Village of Grantsburg

Village Board Meeting Agenda Monday, February 9, 2026 at 4:00 p.m. Village Board Room, 316 S. Brad Street

RE: Change Order 01
Village of Grantsburg
Grantsburg WWTP Improvements
SEH No. 184139 71.50

Change Order No. 1 to the Grantsburg WWTP Improvements project is enclosed. This Change Order includes six (6) items previously approved as individual line items by the Village Board and two (2) items that have not been approved. SEH recommends approval of Change Order No. 1 to incorporate the following changes into the Contract with Market & Johnson, Inc. (Contractor):

NOTE: THIS STRUCTURE IS REQUIRED TO PASS A LEAK TEST PRIOR TO BACKFILLING. CONCRETE SHALL ACHIEVE FULL F'C STRENGTH PRIOR TO START OF LEAK TEST. SEE 01 42 00 WATERTIGHTNESS TESTING SPEC FOR PROCEDURES.

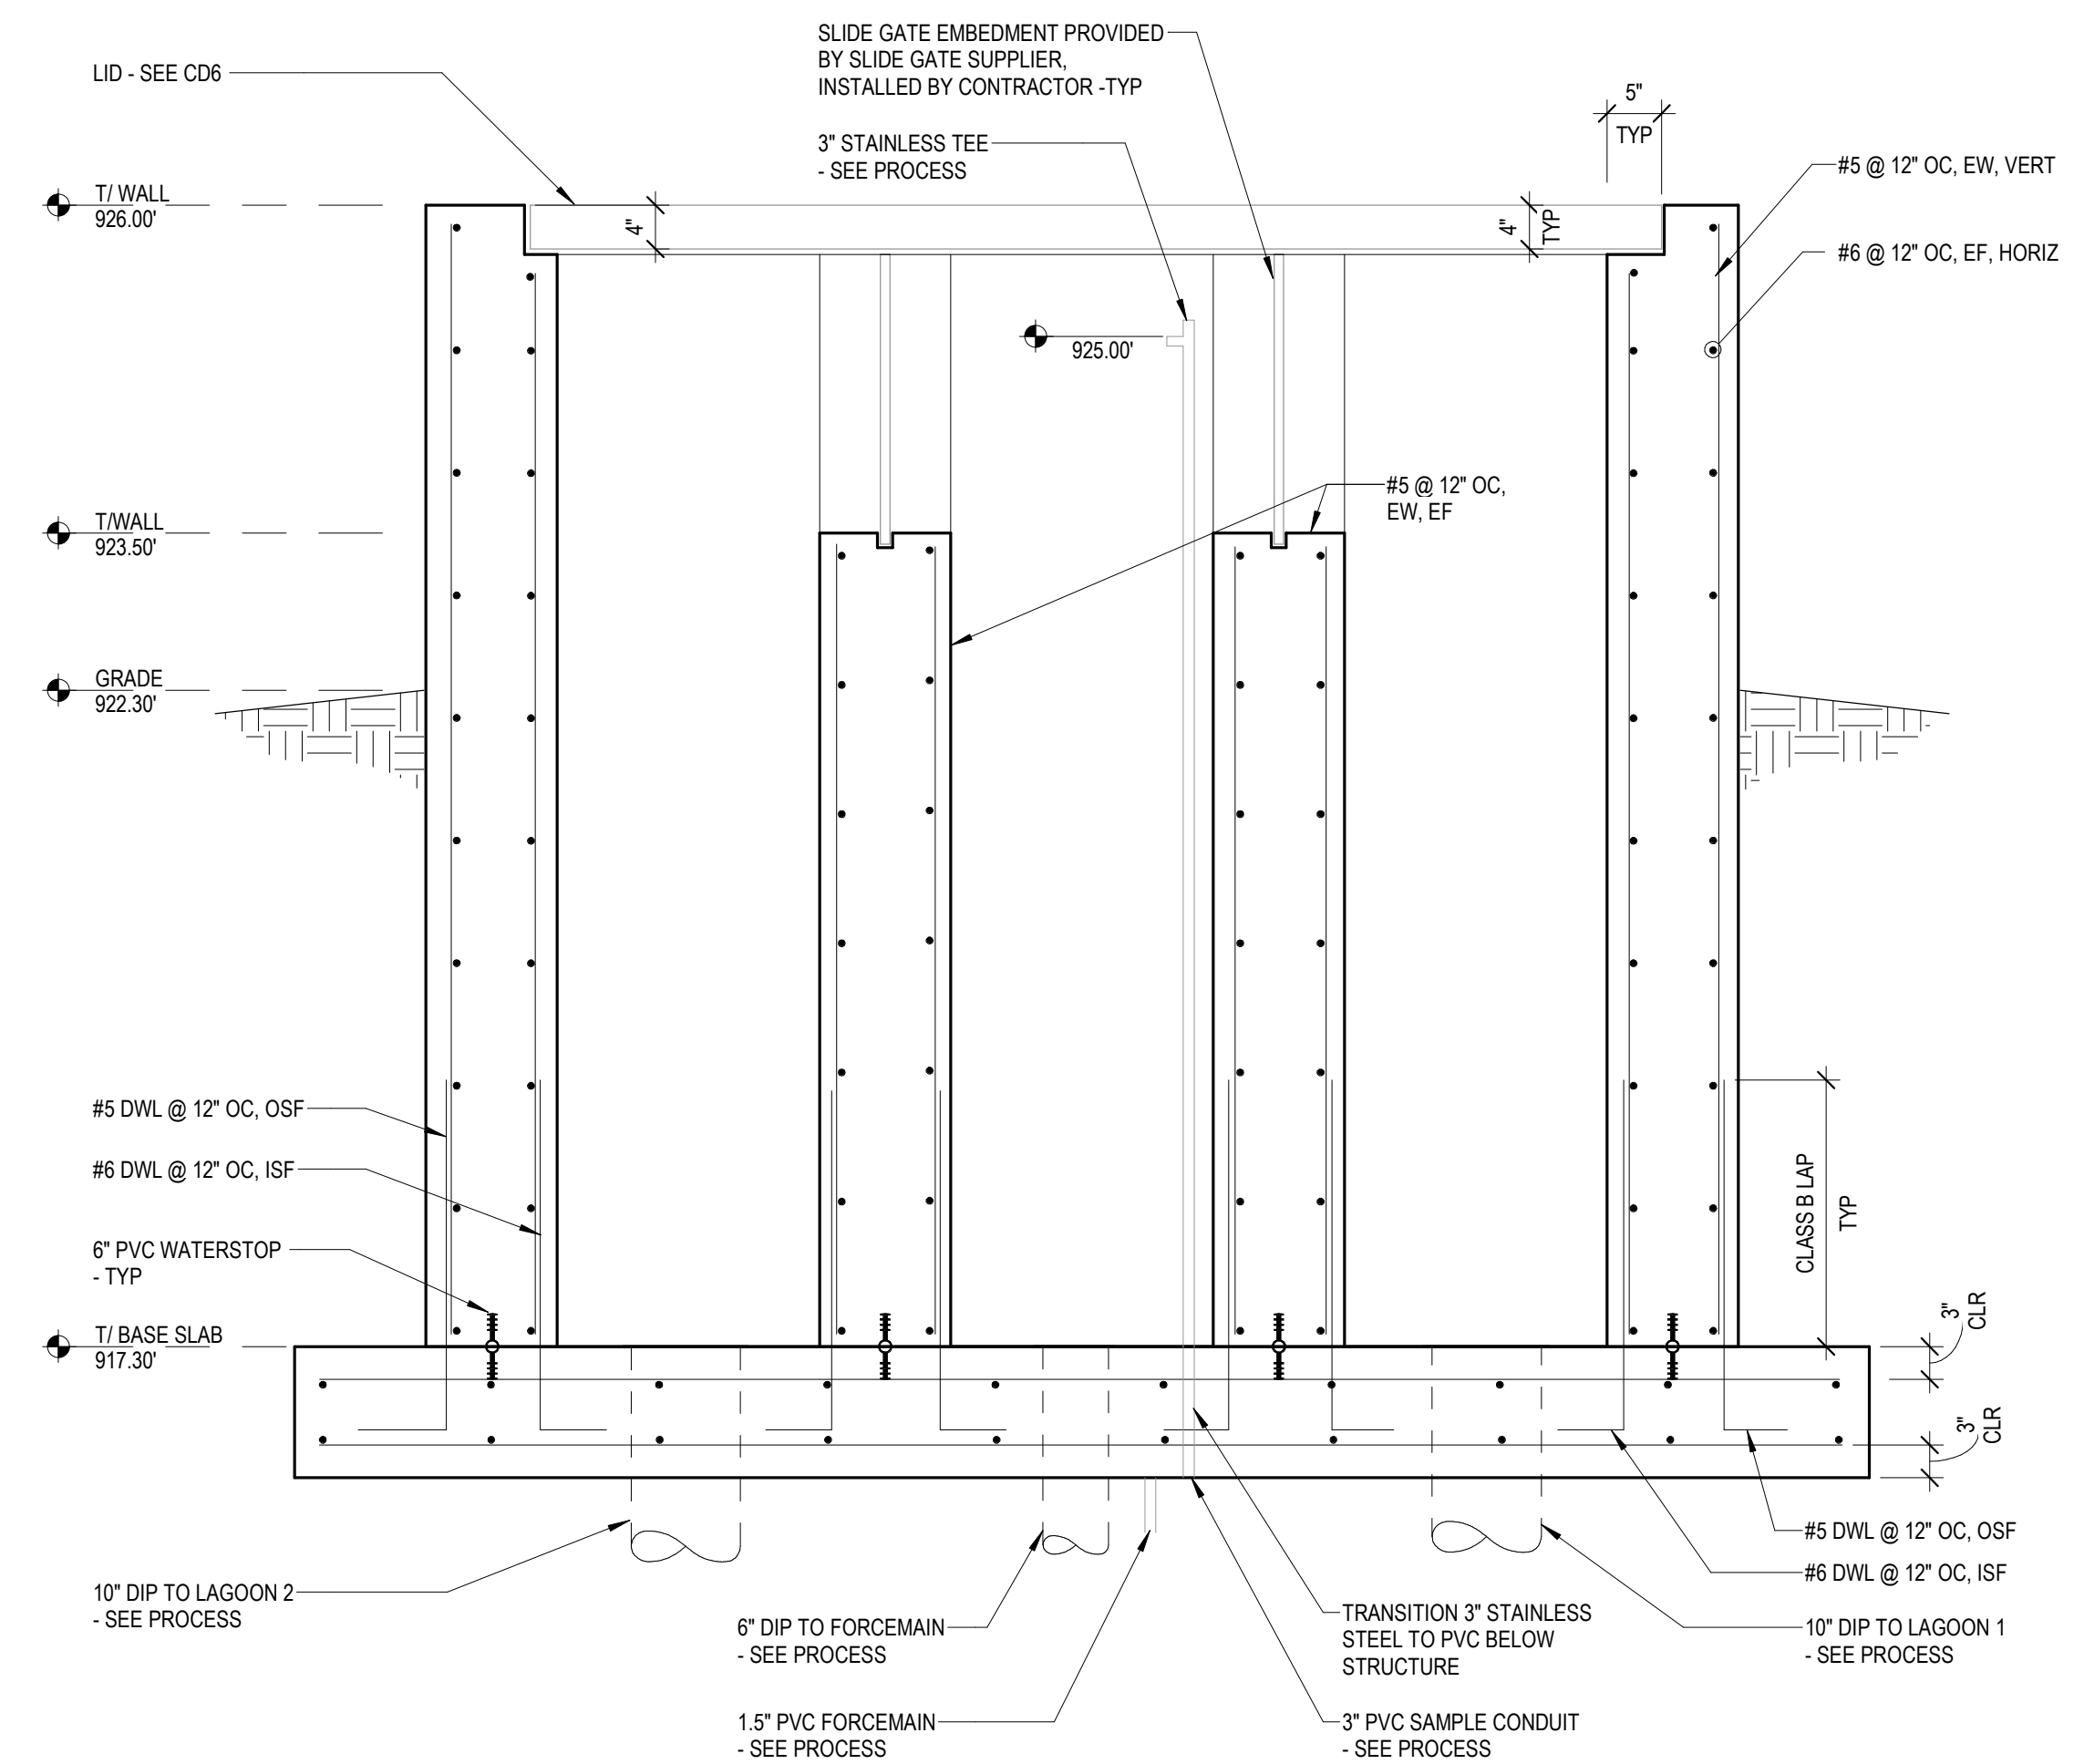
- Change Order Request #07 – Splitter Box Dimension Clarifications (FO #5)**
 Dimensional adjustments result in no change in contract price or time; COR #7 is recommended for approval. This change was approved by the Grantsburg Village Board on December 8, 2025.
